**Pacific Gas and
Electric Company**

July 31, 2017

Subject: Response to DTSC's Geological Services Unit April 6, 2017 Memorandum titled *Proposal for Alternative Groundwater Sampling Trial, Pacific Gas and Electric, Topock Compressor Station*

APPENDIX C-2I SUMMARY OF HYDROGEOLOGIC LOGGING FOR TW-04 WELL

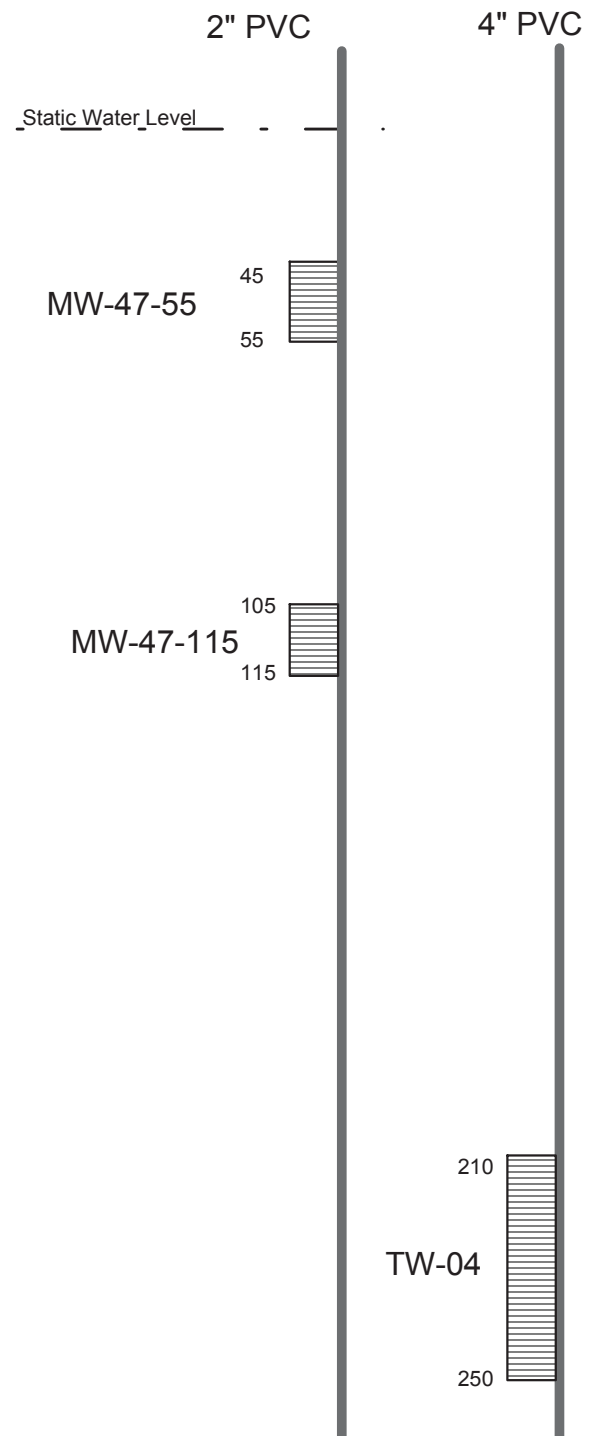
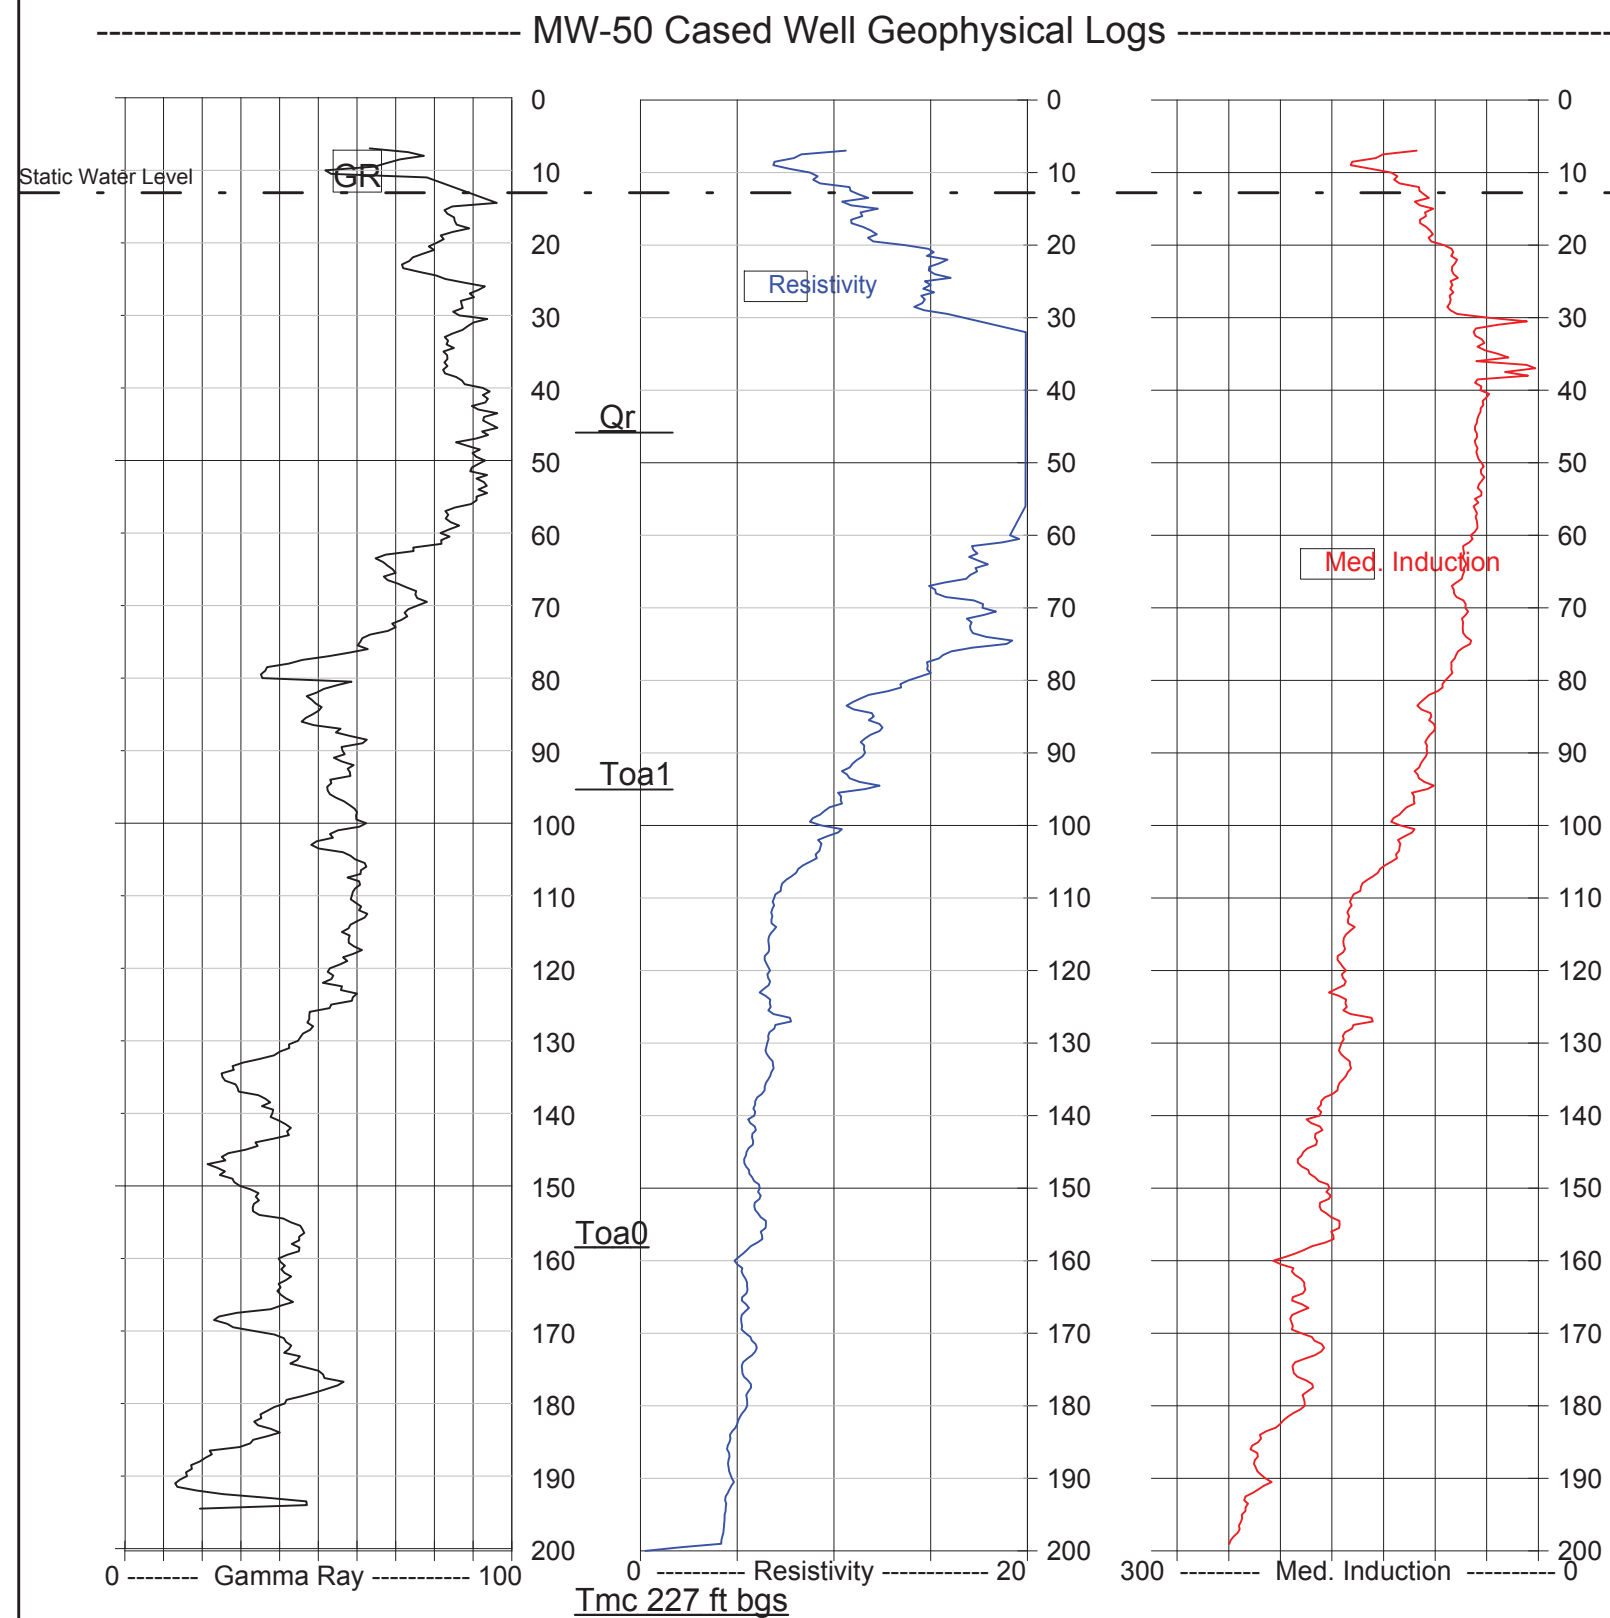
MW-73-080	MD from midscreen	MD approved with SC profile	Accept - Collect SC pH profiles; begin MD sampling in Q4 2017.
OW-03S	MD Trial, midscreen	MD approved with SC profile	Accept - begin MD sampling in Q4 2017, with request for deviation below. <u>Request for deviation from April 2017 Letter:</u> No SC profile for shallow alluvial wells.
TW-01	MD Trial, midscreen	MD specific depths need justification, consider flow tests	<u>Justification:</u> See attached 2003 flow tests and sampling for MD/HS trial at 3 depths (170, 205, and 230-foot depths)
TW-04	MD Trial, midscreen	Not in DTSC response	<u>Request DTSC approval:</u> Conduct MD vs. 3V trial, MD specific depth 222 feet (log attached), SC profile.
TW-05	MD Trial, midscreen	Not in DTSC response	<u>Request DTSC approval:</u> Conduct MD vs. 3V trial, MD specific depth 147 feet (log attached), but No SC profile (well is not screened near bedrock so no SC profile).

FIGURE B2-1
SUMMARY OF HYDROGEOLOGIC LOGGING
FOR CW-1 COMPLIANCE WELLS
IM-3 GROUNDWATER INVESTIGATION
PG&E TOPOCK COMPRESSOR STATION
NEEDLES, CALIFORNIA

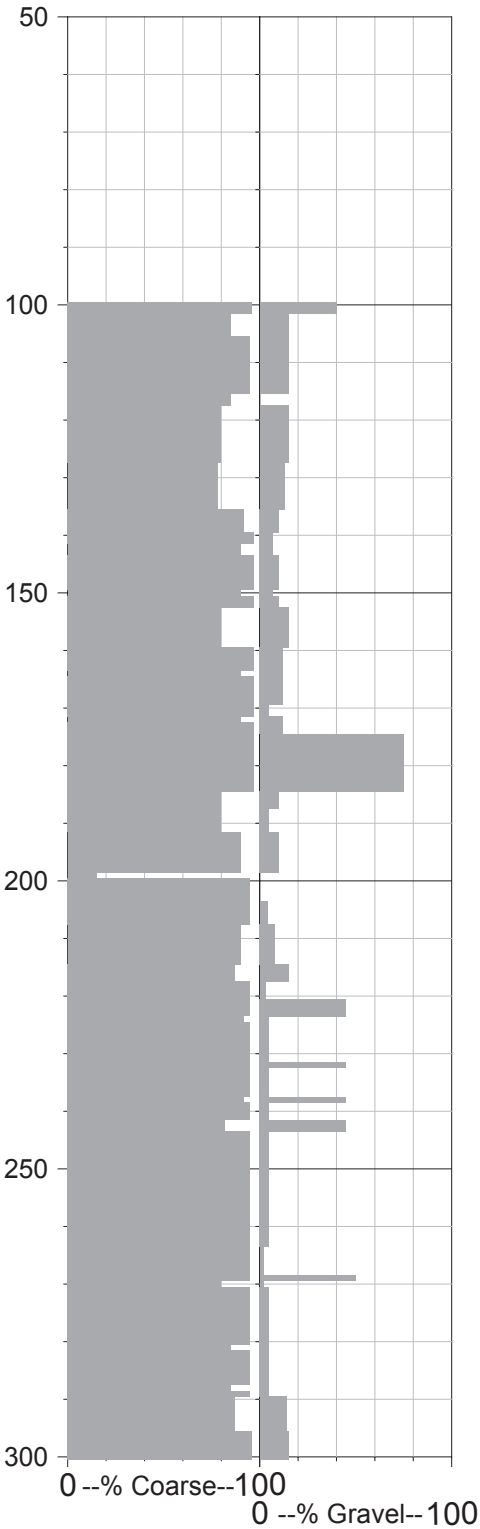
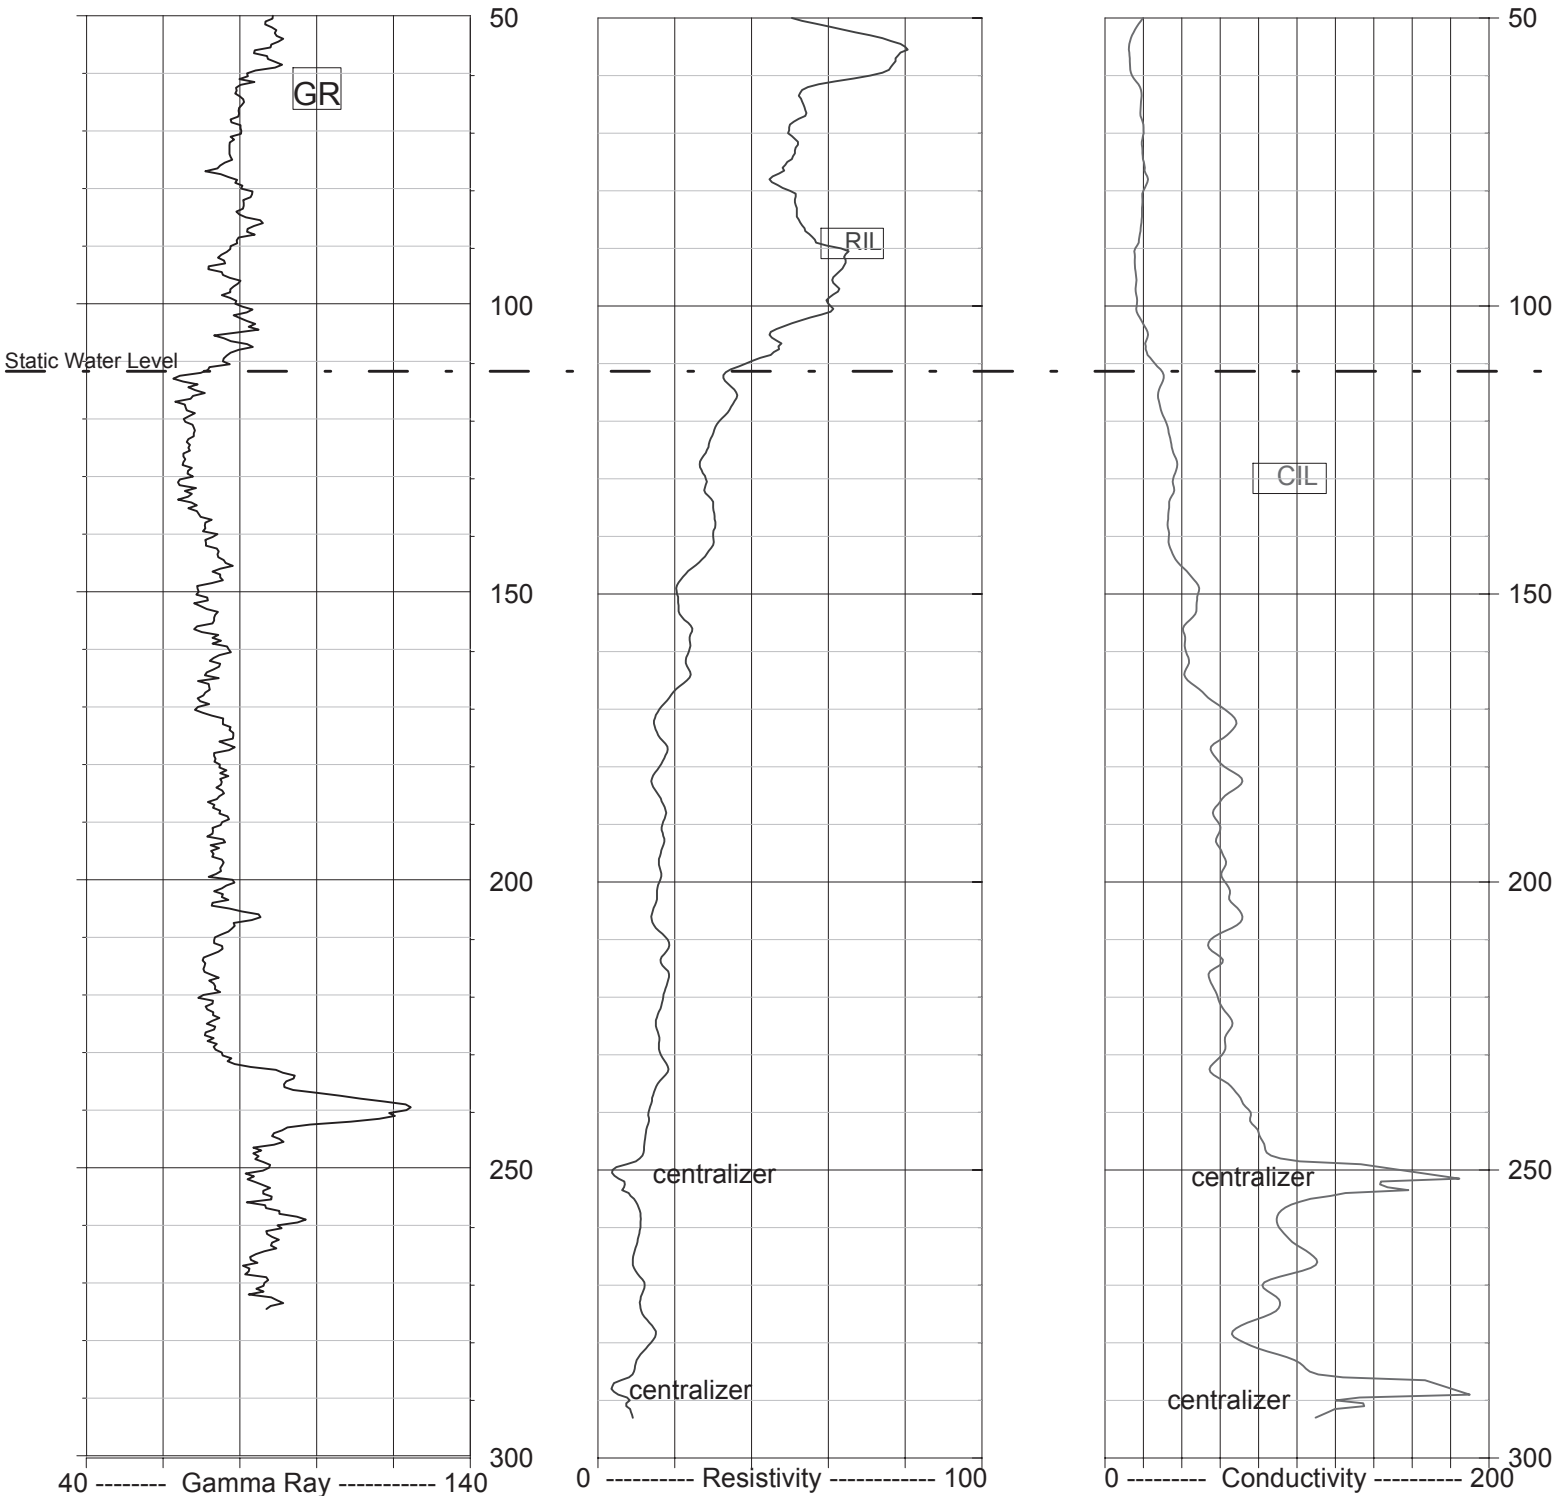
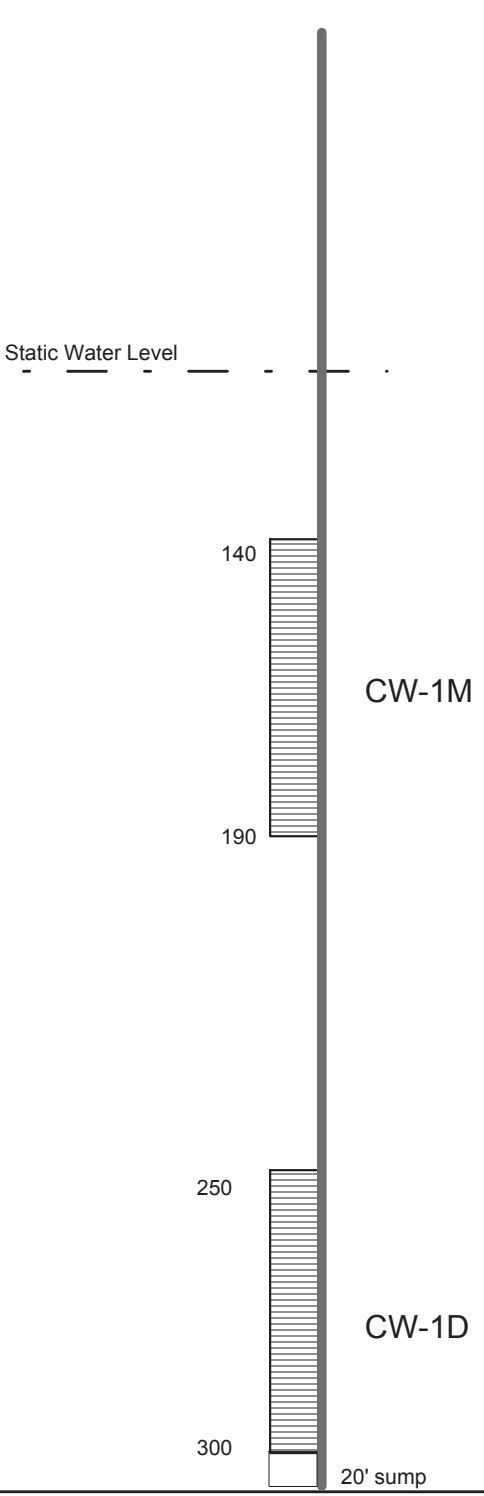
MW-60-125, MW-74-240, OW-3S; OW-1S, OW-1M, OW-1D, OW-2S, OW-2M, OW-2D, and OW-5D	Change to MD with pump at mid- screen	MD approved with SC profile approved in these wells with 30-foot or shorter screens.	Accept – begin MD sampling in Q4 2017 and SC profile the deep screen “D” wells, with request for deviation below. <u>Request for deviations from April 2017 Letter:</u> 1) No SC profile for shallow alluvial wells screened above bedrock.
OW-5S, OW-5M, CW-1M, CW-1D, CD-2M, CW-2D, CW-3M, CW-3D, CW-4M, CW-4D	MD Trial, midscreen	MD Trial approved with SC profile and flow testing to select MD sampling depths in these wells with 40 to 50-foot screens	2) logs (attached) were reviewed to select MD sampling depths (feet bgs) for Trial in longer screen wells, because flow testing not practical in 2-inch wells: - OW-5S 107 feet, OW-5M 240 feet - CW-1M 175 feet, CW-1D 267 feet - CW-2M 177 feet, CW-2D 317 feet - CW-3M 197 feet, CW-3D 297 feet - CW-4M 150 feet, CW-4D 280 feet
